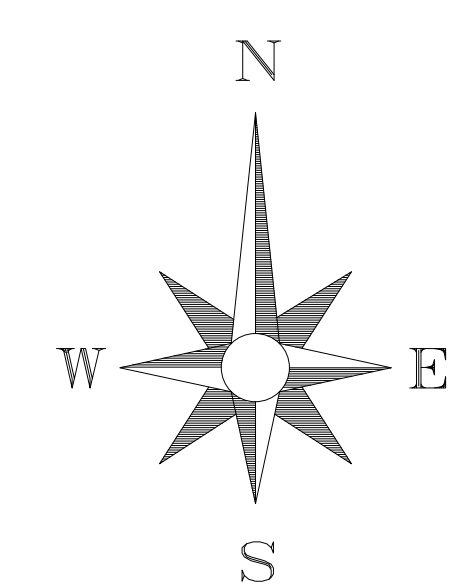
| E | Boundaries Revised/Changed - See Clouds | APM | 19.04.23 |
| D | Reference to railing added where hedge planting occurs | JL | 11.03.22 |
| C | Boundary details between the side gardens of plots 99 and 110 amended to an acoustic fence. | JL | 28.10.21 |
| B | Boundary details revised to meet secure by design requirements and LA comments. Rear boundaries amended to 1.8m close boarded fence following recommendations in the crime impact statement/secure by design. 2.1m walls and fencing noted to exposed location. | NB | 21.10.21 |
